# Development Management Sub Committee

Wednesday 12 January 2022

**Application for Planning Permission 21/03756/FUL  
at 9 Haymarket Terrace, Edinburgh.  
Demolition of existing and proposed new-build office  
development (class 4) with associated ancillary uses,  
public realm, landscaping and car parking.**

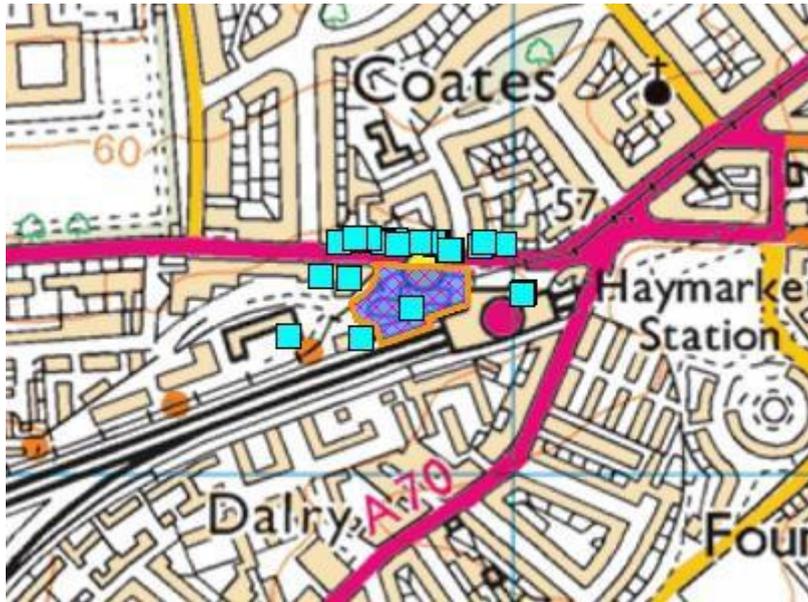
*The site is located within the immediate setting of the World Heritage Site, and given its location and proposed scale has the potential to impact on both local townscape character and the skyline/longer view elements associated with the OUV of the World Heritage Site outlined above.*

*The proposals therefore merit careful consideration with respect to their impact on OUV. The visuals provided are not sufficient to assess the impact of the proposals on the OUV of the World Heritage Site.*

*In order to enable a reasonable assessment of the proposals impact in line with relevant legislation and policies regarding managing change the historic environment, we advise that further information is provided by the applicant to inform consideration of this application.*

*Fully verified views from the relevant points identified in the Edinburgh Design Guidance, alongside those informed by the expertise within the planning development, would be advised.*
